Access Compliance Report

Public Rights-of-Way

Intersection ID: 18973	Main Street: ARBOR_WY	Cross Street: PELHAM_LN	Location: SE
ADA ID: 486202CF4348	Ramp Type: PerpDiag	Initial Pass/Fail: Fail	Overall Compliance: No
Severity Score: 33.75			
Codes/Mitigation Info/Possible Solution		Field Measurements/Component Compliance

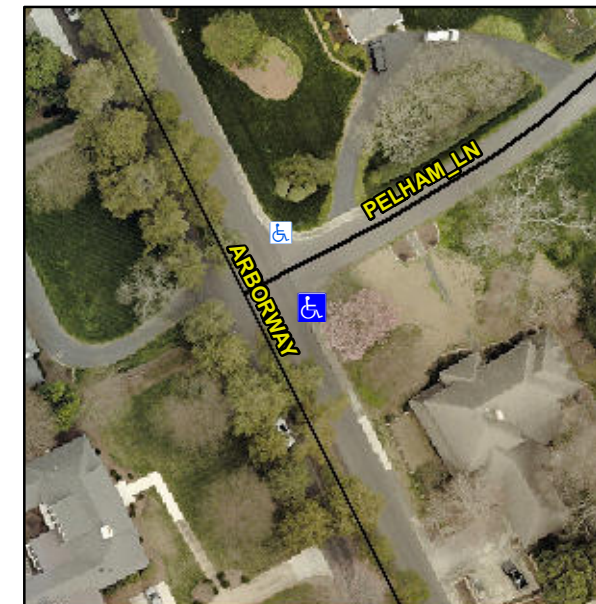
Not Found, R304.5.1, R304.2.2

Compliance	Description	Data	Compliance	Description	Data
N/A	Ramp Length (in)	38.0	No	Ramp Slope (%)	15.7
No	Ramp Width (in)	38.0	Yes	Ramp XSlope (%)	0.6
N/A	Flare Type LT	N/A	N/A	Flare Type RT	N/A
N/A	Flare Slope LT (%)	N/A	N/A	Flare Slope RT (%)	N/A
N/A	Flare Traversable LT?	N/A	N/A	Flare Traversable RT?	N/A
N/A	Landing Length (in)	N/A	N/A	DWS Provided?	N/A
N/A	Landing Width (in)	N/A	N/A	DWS Contrast?	N/A
N/A	Landing Slope (%)	N/A	N/A	DWS Length (in)	N/A
N/A	Landing X Slope (%)	N/A	N/A	DWS Full Width?	N/A
N/A	Landing Curb? (Y/N)	N/A	N/A	DWS Offset (in)	N/A
N/A	Shared Landing?	N/A			
N/A	Gutter Ponding?	N/A	N/A	Gutter Slope (%)	N/A
N/A	Gutter Lip Ht (in)	N/A	N/A	Gutter X Slope (%)	N/A
N/A	Painted X Walk1?	No	N/A	Painted X Walk2?	No
	X Walk 1 Direction	To N		X Walk 2 Direction	To W
N/A	X Walk 1 Width (in)	N/A	N/A	X Walk 2 Width (in)	N/A
	X Walk 1 Slope (%)	3.9		X Walk 2 Slope (%)	4.1
	X Walk 1 X Slope (%)	2.8		X Walk 2 X Slope (%)	1.5

Remove & Replace Curb Ramp With Two New Directional Ramps or Equivalent.
